Docket Nos. 50-250
and 50-251

Subject: Technical Specification Amendments to Support the Integrated Program
for Vessel Flux Reduction and Operation with the New Steam Generators

ATTACHMENT TO LICENSE AMENDMENTS

SAFETY EVALUATION BY THE OFFICE OF NUCLEAR REACTOR REGULATION
RELATED TO AMENDMENT NO. 99 TO FACILITY OPERATING LICENSE NO. DPR-31
AND AMENDMENT NO. 93 TO FACILITY OPERATING LICENSE NO. DPR-41
FLORIDA POWER AND LIGHT COMPANY
TURKEY POINT PLANT UNIT NOS. 3 AND 4
DOCKET NOS. 50-250 AND 50-251

Figure 2.1-1 Reactor Core Thermal and Hydraulic
Safety Limits, Three Loop Operation

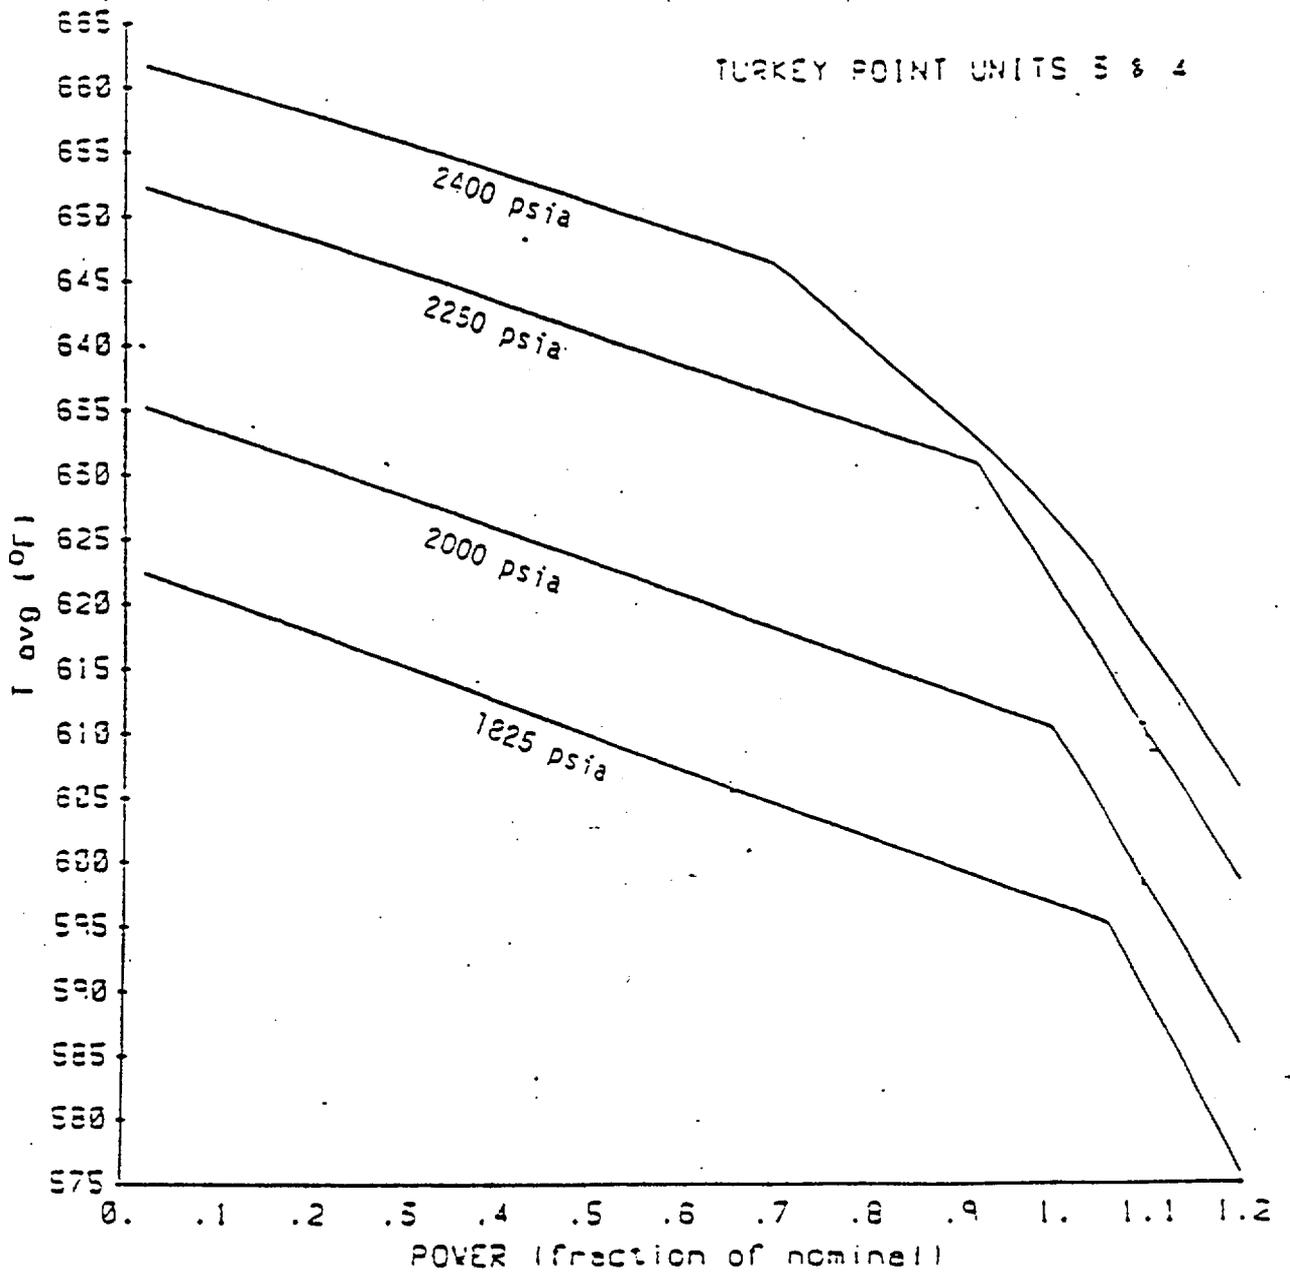
Figure 2.2-1

This figure has been modified to remove the "note", which is no longer applicable with the new steam generators.* The limits were recalculated to reflect the increase in the allowable $F_{\Delta H}$ limit, and is acceptable as discussed in Section 4.1.

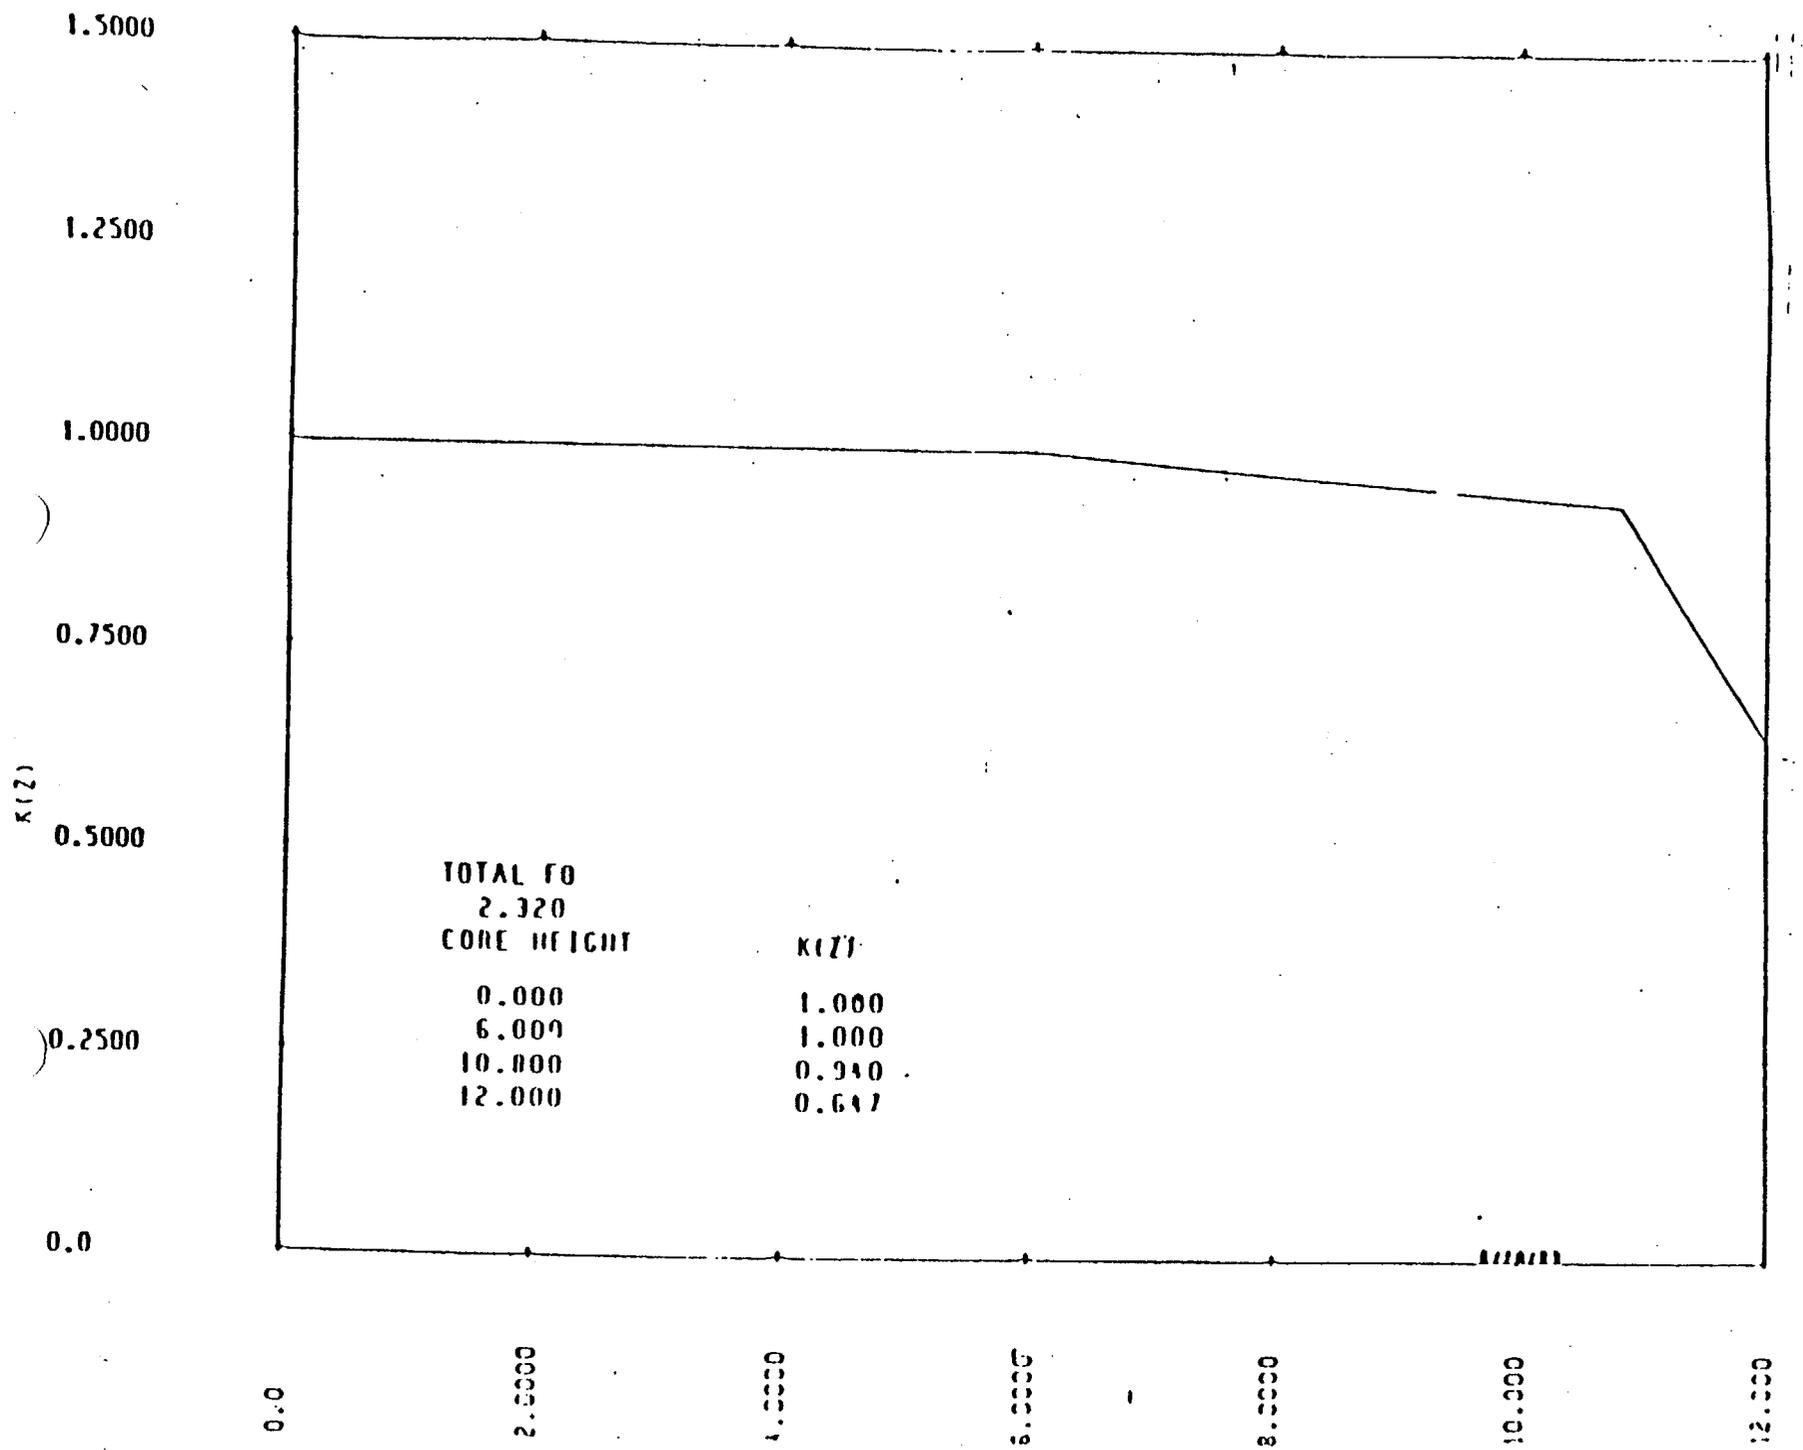
Figure 3.2-3 & 3.2-3a

These figures have been combined into Figure 3.2-3 and revised to present new limits from the LOCA analyses. We calculated this figure independently and agree that it is correct, and therefore this change is acceptable.
